SUBJECT: Second Early Action Record of Decision Remedial Alternative Selection for the D-Area Operable Unit (U) (SRNS-RP-2018-00461, Revision I Redline, July 2020) and Savannah River Site's Responses to the Regulatory Comments on the Revision 0 Document, SEMS Number: 63

**SRS Responses to
UNITED STATES ENVIRONMENTAL PROTECTION AGENCY
Comments on the
Second Early Action Record of Decision
Remedial Alternative Selection for the D-Area Operable Unit**

SEMS Number: 63 / SRNS-RP-2018-00461 / Revision 0 / Dated: February 2020

Comments Received: June 1, 2020

Figure 3. Layout of the DAOU

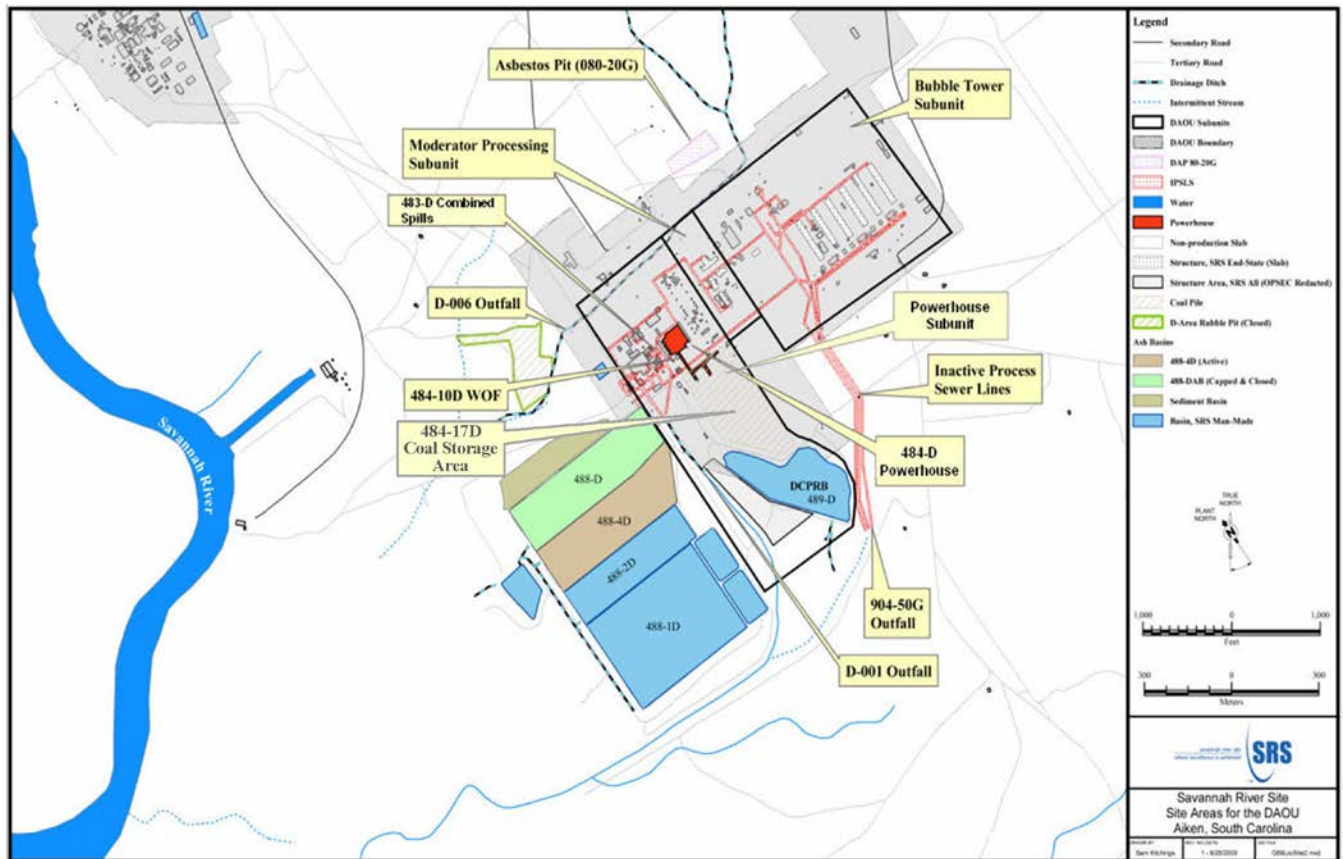
2. **Figure 3 Layout of the DAOU, Page 55 of 70 and Figure 4 D-Area Project Site Phase 1 and Phase 2, Page 56 of 70:** The D-Area Coal Storage Area (484-17D) subunit where coal was excavated and placed into the 488-4D Ash Landfill for disposal is discussed in EA ROD; however, the location of the subunit is not defined in any of the site figures. Revise the figures as appropriate to ensure the location of the D-Area Coal Storage Area subunit relative to the
-

Ash Basin 488-D, Ash Landfill 488-4D, Ash Basin 488-2D, Ash Basin 488-1D and the CPRB is clearly documented and understood.

Response: Agree. Figure 3. Layout of the DAOU and Figure 4. D-Area Project Site, Phase 1 and Phase 2 will be revised to show the location of the D-Area Coal Storage Area (484-17D). The revised figures are attached to these comment responses (Attachment 1 and Attachment 2).
